Access Compliance Report

Public Rights-of-Way

Intersection ID: 48558	Main Street: ARDREY_WOODS_DR	Cross Street: N/A	Location: W
ADA ID: 829C07D7976B	Ramp Type: PerpDiag	Initial Pass/Fail: Fail	Overall Compliance: No
		Severity Score: 30

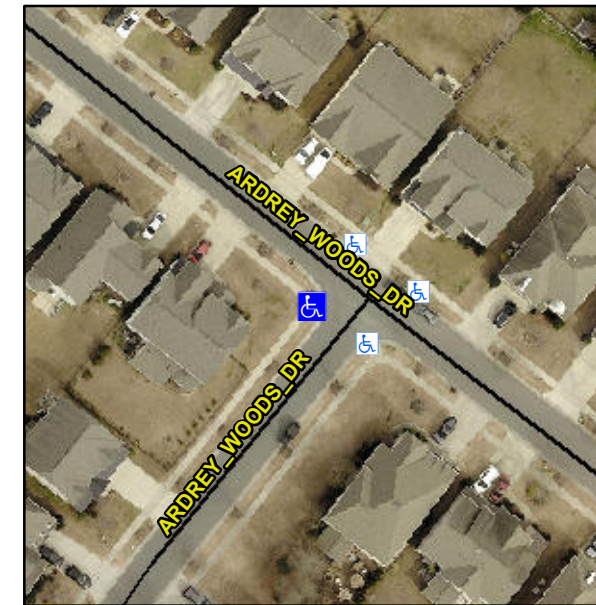
Not Found, R304.5.1, R304.5.3

Compliance	Description	Data	Compliance	Description	Data
N/A	Ramp Length (in)	72.0	Yes	Ramp Slope (%)	5.3
No	Ramp Width (in)	33.0	No	Ramp XSlope (%)	6.3
N/A	Flare Type LT	N/A	N/A	Flare Type RT	N/A
N/A	Flare Slope LT (%)	N/A	N/A	Flare Slope RT (%)	N/A
N/A	Flare Traversable LT?	N/A	N/A	Flare Traversable RT?	N/A
N/A	Landing Length (in)	N/A	N/A	DWS Provided?	N/A
N/A	Landing Width (in)	N/A	N/A	DWS Contrast?	N/A
N/A	Landing Slope (%)	N/A	N/A	DWS Length (in)	N/A
N/A	Landing X Slope (%)	N/A	N/A	DWS Full Width?	N/A
N/A	Landing Curb? (Y/N)	N/A	N/A	DWS Offset (in)	N/A
N/A	Shared Landing?	N/A			
N/A	Gutter Ponding?	N/A	N/A	Gutter Slope (%)	N/A
N/A	Gutter Lip Ht (in)	1.0	N/A	Gutter X Slope (%)	N/A
N/A	Painted X Walk1?	No	N/A	Painted X Walk2?	No
	X Walk 1 Direction	To SE		X Walk 2 Direction	To NE
N/A	X Walk 1 Width (in)	N/A	N/A	X Walk 2 Width (in)	N/A
	X Walk 1 Slope (%)	2.2		X Walk 2 Slope (%)	3.6
	X Walk 1 X Slope (%)	3.6		X Walk 2 X Slope (%)	0.5

Remove & Replace Curb Ramp With Two New Directional Ramps or Equivalent.
